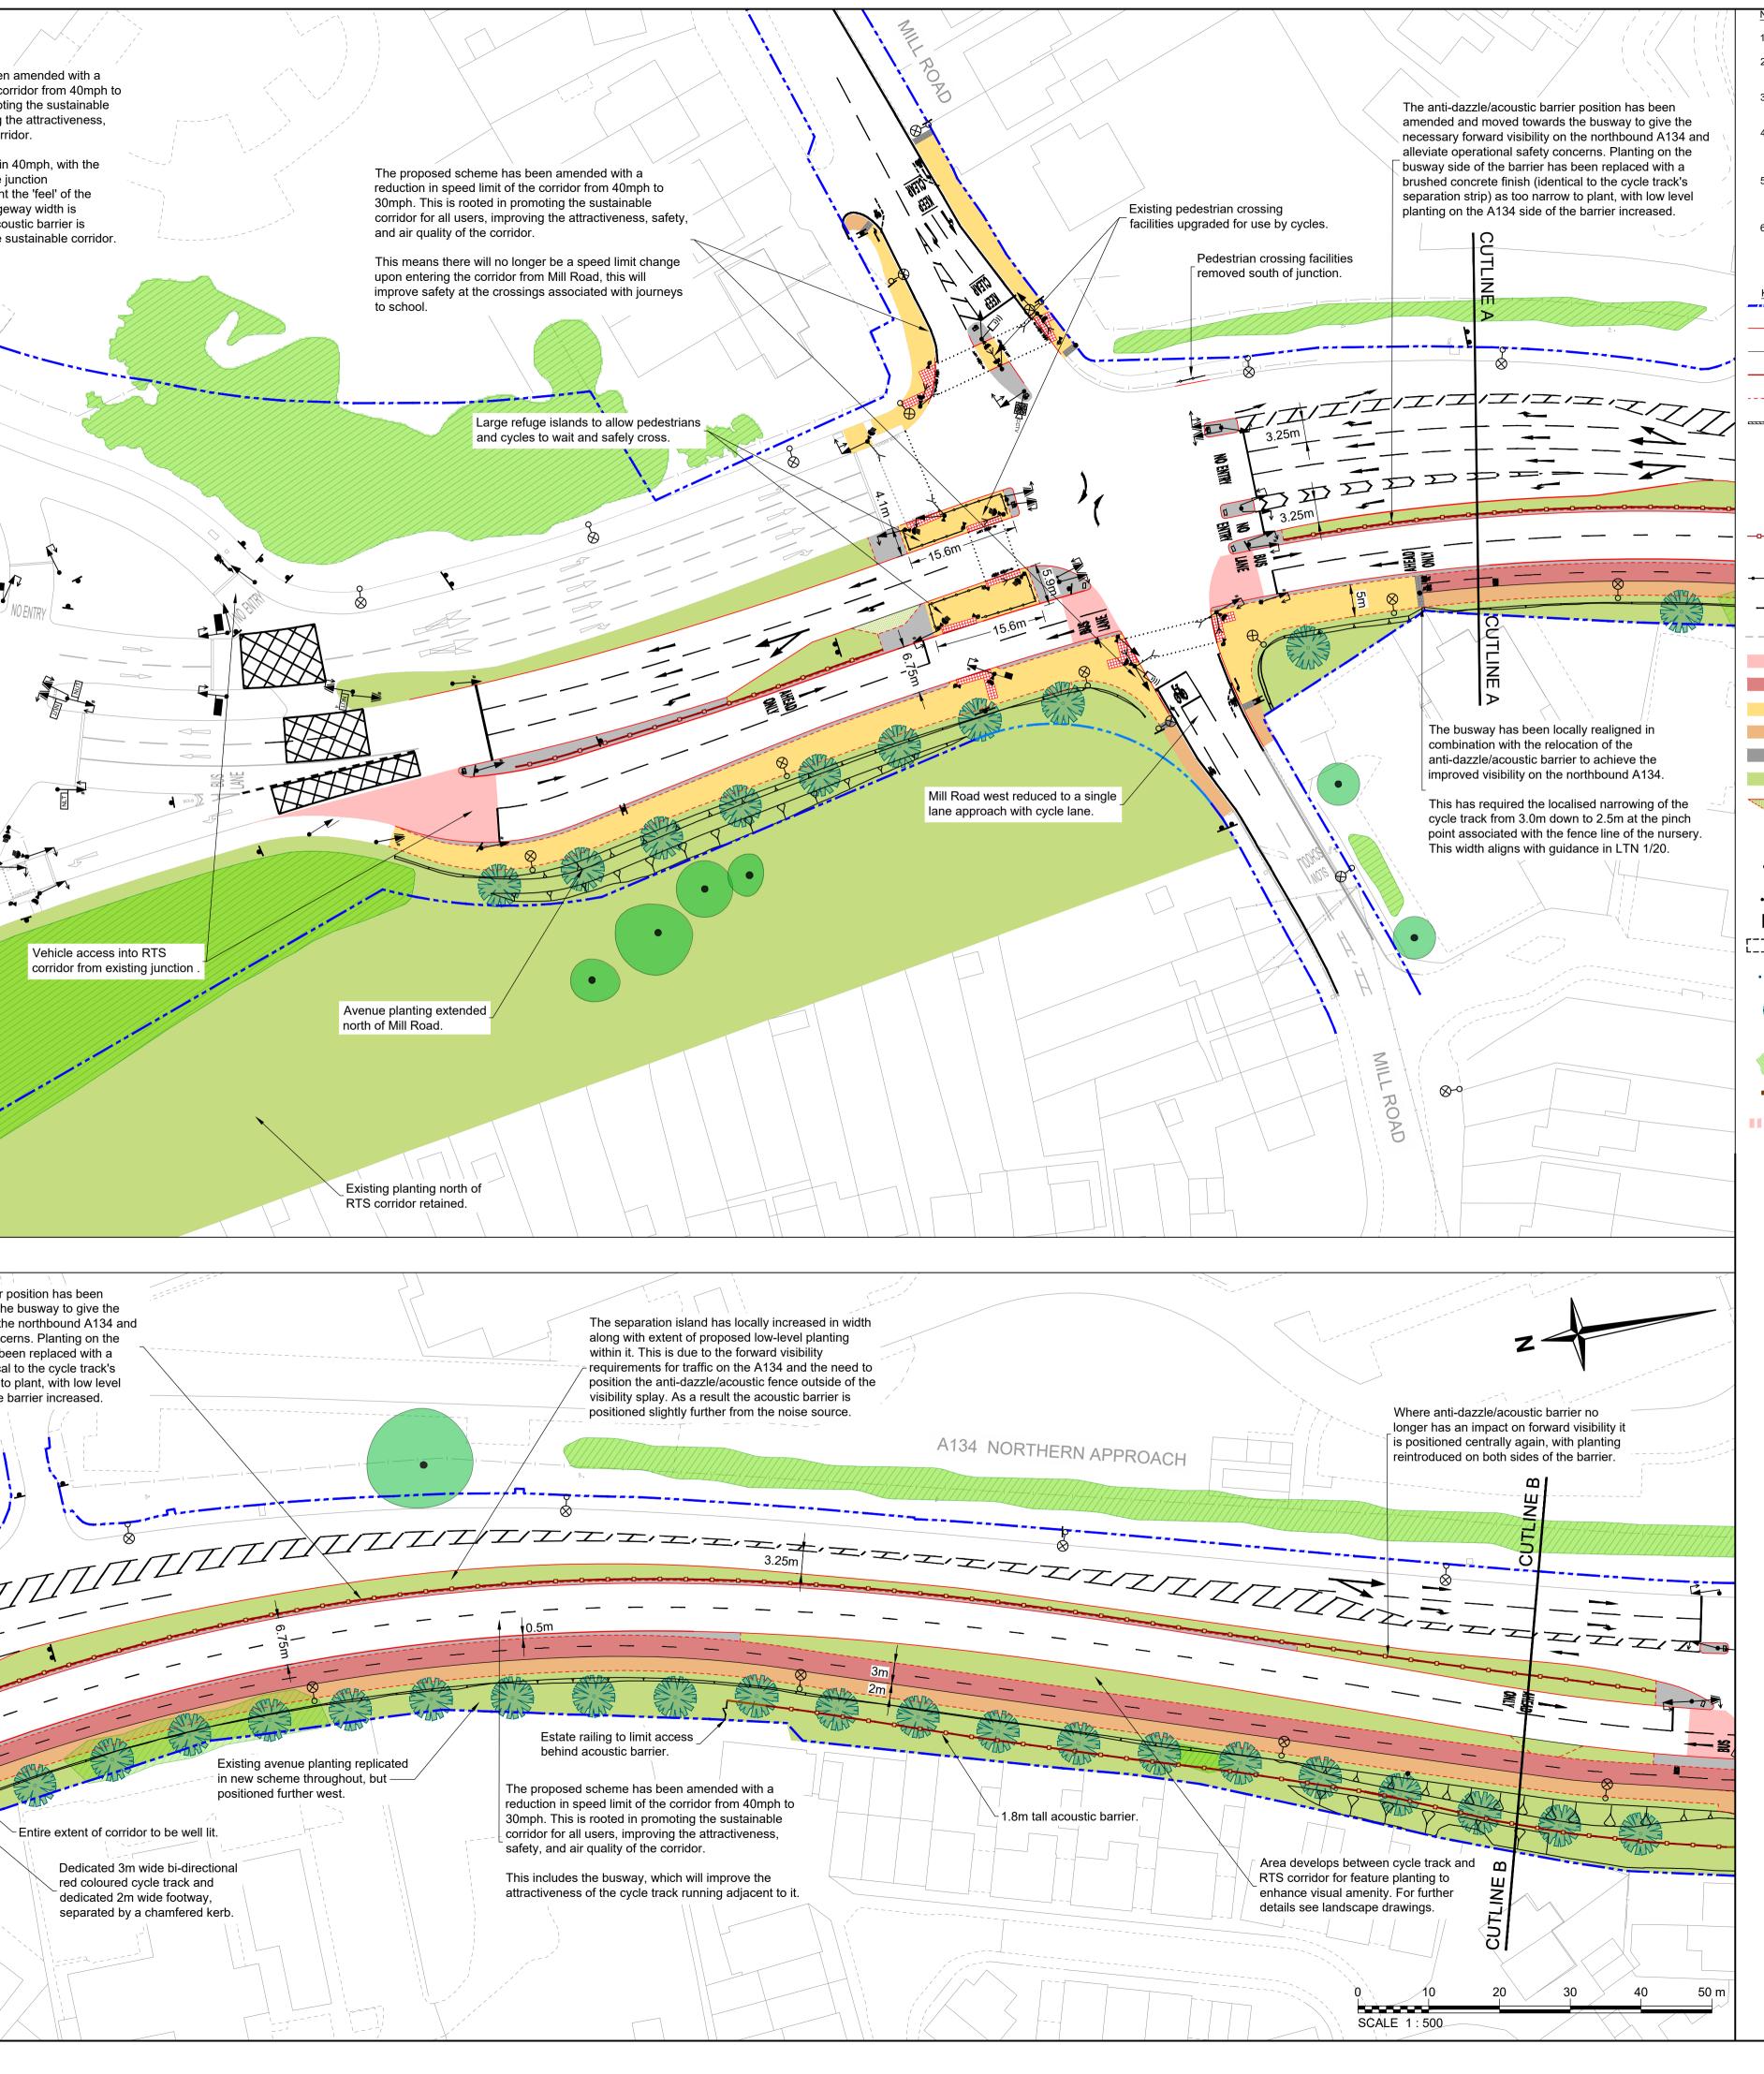
The proposed scheme has been amended with a reduction in speed limit of the corridor from 40mph to 30mph. This is rooted in promoting the sustainable corridor for all users, improving the attractiveness, safety, and air quality of the corridor. Via Urbis Romanane will remain 40mph, with the speed limit change north of the junction arrangement. South of this point the 'feel' of the / corridor changes as the carriageway width is reduced and the anti-dazzle/acoustic barrier is introduced, associated with the sustainable corridor. Ĥ To provide continuity with the surrounding area, the Vehicle access into RTS A134 Northern Approach Road up to the Boxted corridor from existing junction. Road roundabout is to also be reduced in speed. This will mean vehicles entering the sustainable corridor from this arm of the junction are already subject to a 30mph speed limit.

> The anti-dazzle/acoustic barrier position has been amended and moved towards the busway to give the necessary forward visibility on the northbound A134 and alleviate operational safety concerns. Planting on the busway side of the barrier has been replaced with a brushed concrete finish (identical to the cycle track's separation strip) as too narrow to plant, with low level planting on the A134 side of the barrier increased.

> > Existing avenue planting replicated in new scheme throughout, but positioned further west.
